RENESAS TECHNICAL UPDATE

Product Category	MPU & MCU		Document No.	TN-RX*-A070A/E	Rev.	1.00
Title	Errata to RX Family User's Manuals Regarding the RIIC Module		Information Category	Technical Notification		
Applicable Product	RX610 Group, RX62N Group, RX621 Group, RX62G Group, RX62T Group, RX630 Group, RX63N Group, RX631 Group, RX63T Group, RX210 Group, RX220 Group, RX21A Group	Lot No. All	Reference Document	User's Manual: Hardware for applicable products (see the table at the last page)

This document describes corrections and additions to the "I²C Bus Interface (RIIC)" chapter in User's Manual: Hardware for the applicable products.

Figure 33.XX Example of Master Reception (7-Bit Address Format, 1 or 2 bytes)

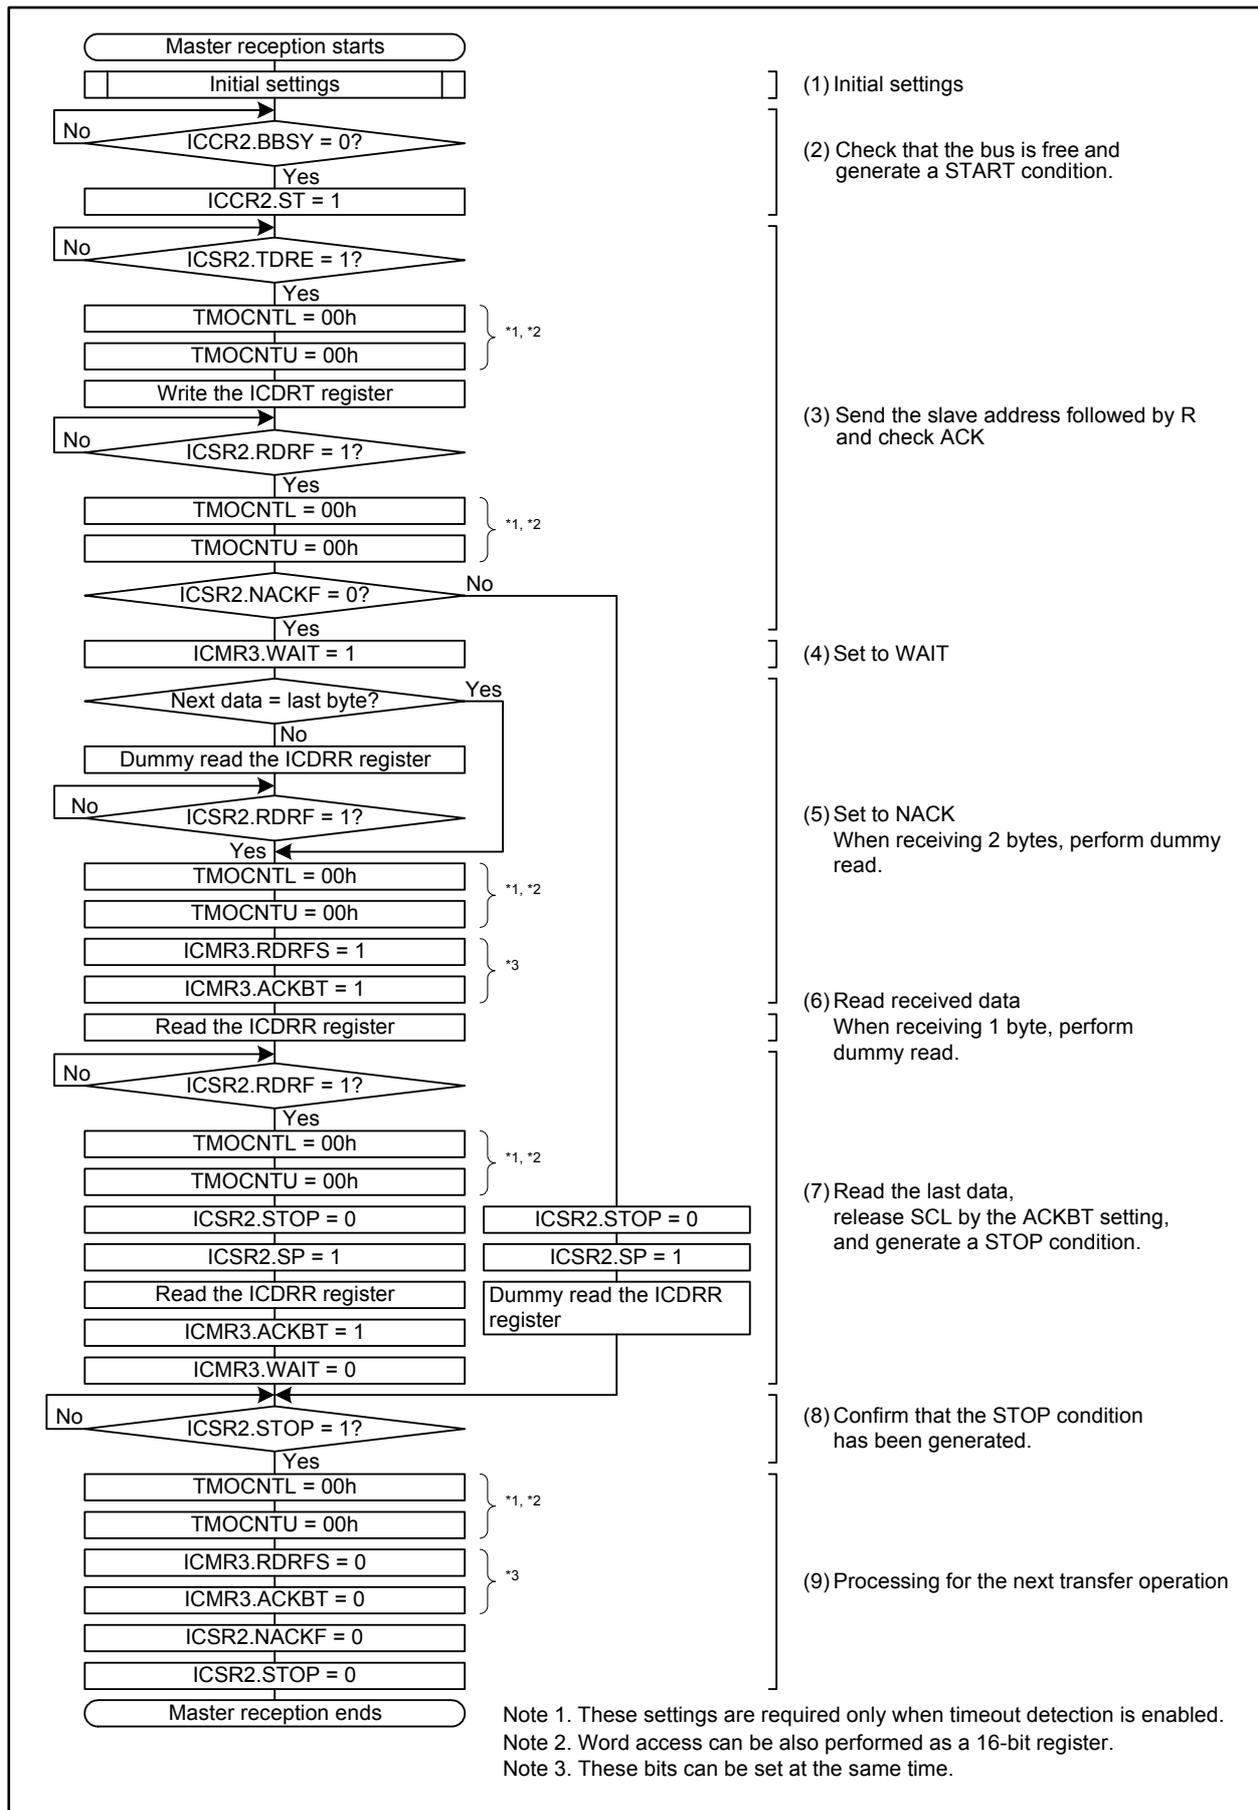
The following figure is added to 33.3.4 “Master Receive Operation.”
